## SERVICE LETTER # 26

**SUBJECT:** Nose Gear Piston - P/N 35020.000

**TO:** Vixen S/N ECV-001 through LCV-023

**FROM:** SkyStar Aircraft, Engineering Division

**Figure A**

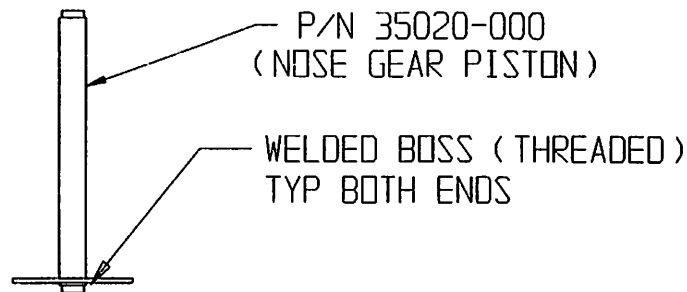
It has come to our attention that a few Vixen customers received a Nose Gear Piston (P/N 35020.000) without a welded boss on both ends. Please inspect the Nose Gear Piston to verify that you have a welded boss on both ends per Figure A. If the welded boss is missing, please call our Customer Service Department at (208) 466-1711 for a RMA (Return Merchandise Authorization) number. For domestic customers, return the Nose Gear Piston back to SkyStar and we will ship you a replacement. International customers will be shipped a new P/N 35020.000 Nose Gear Piston - no return is necessary.
